1986 - 1987 Corvette: Service Bulletin: Clutch Master Cylinder Push Rod Bushing

Subject: Clutch Master Cylinder Push Rod Bushing
Model Year: 1986 - 1987 Corvette with Manual Transmission
Source: Chevrolet Dealer Service Bulletin
Bulletin No: 87-114, Section 7C
Date: April, 1987

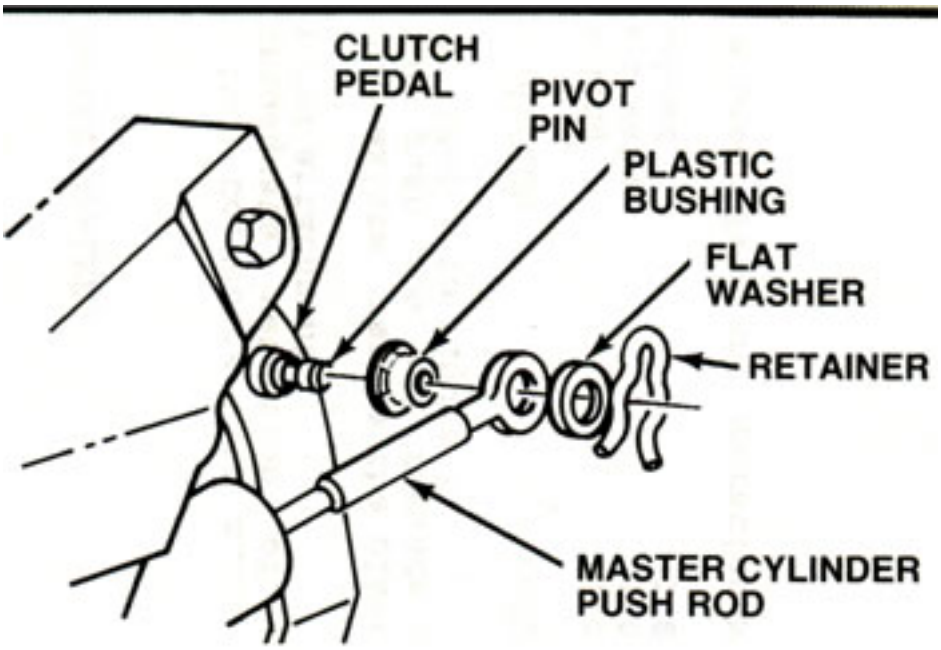
Some 1986 or 1987 Corvettes with manual transmissions may experience inadequate retention of the clutch master cylinder push rod attachment.

If the condition exists, remove the plastic bushing from the master cylinder push rod and replace with the following service parts. (Refer to Figure 1):

DESCRIPTION	PART NUMBER
Bushing	14080233
Flat Washer	120395
Retainer	148149
